Modification to run CPU09CMI on 5MHz bus.

On top side:

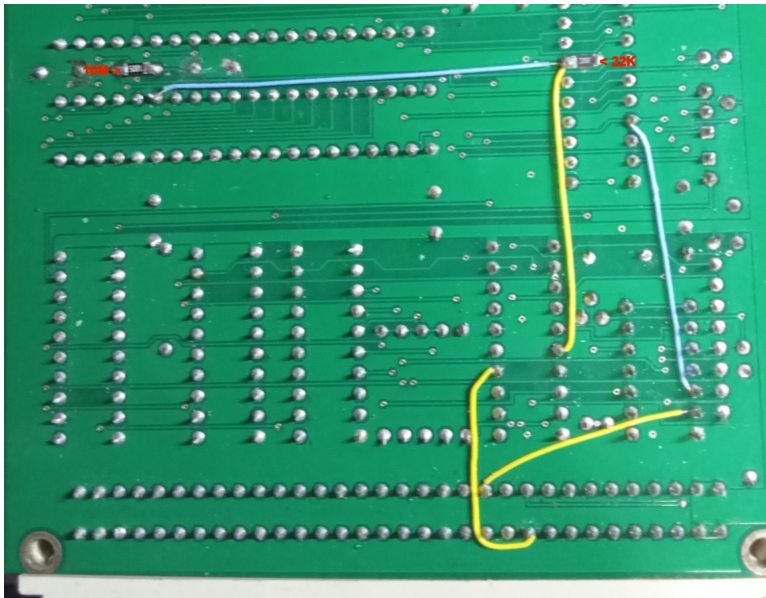
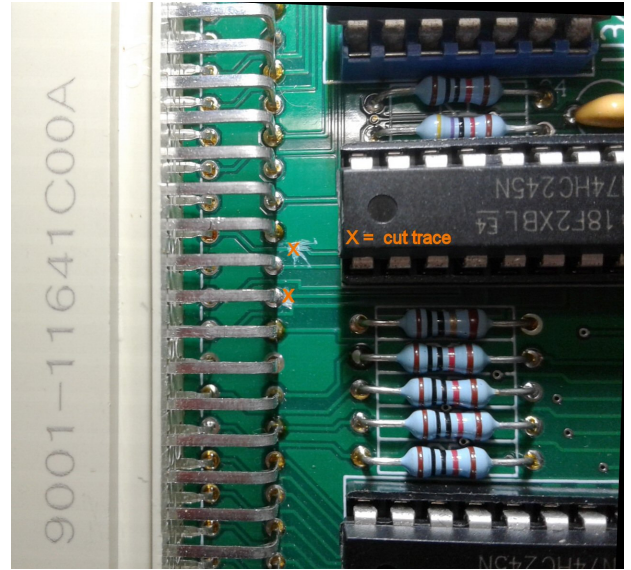
Cut trace between U4-14 and J1 C-21 (B_VMA-)

For REV:0.9 print only cut trace from J1 A23 to R15

On solder side:

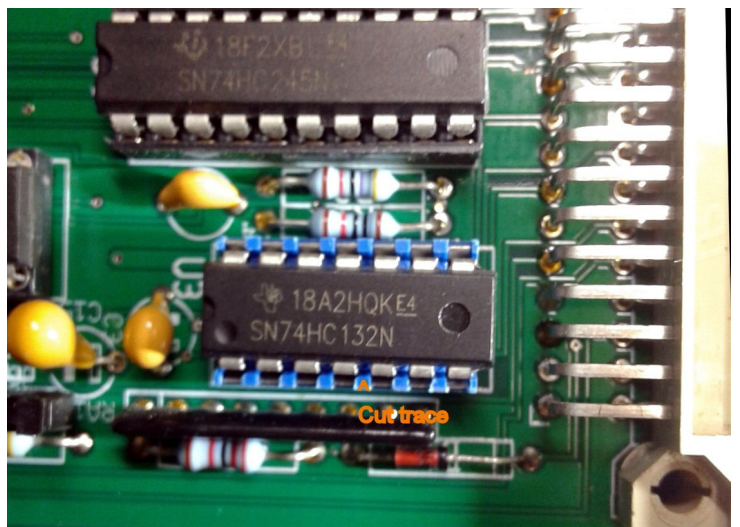
Cut trace between U13-19 and via (OVMA-)

Place 22K resistor between U13-19 and Gnd

Place wire from U6-35 to U13-19 (blue) and U4-6 (Q) (yellow)

Place wire from U4-14 to J1 A-23 (B_Q) (yellow)

Place wire from U3-7 to J1 C-21 (B_VMA-), **Or:**
To keep CPU09CMI 68x02 compatible
or need VMA- signal with 68x02 on the bus
for CPU09GPP or CPU09RAM card.
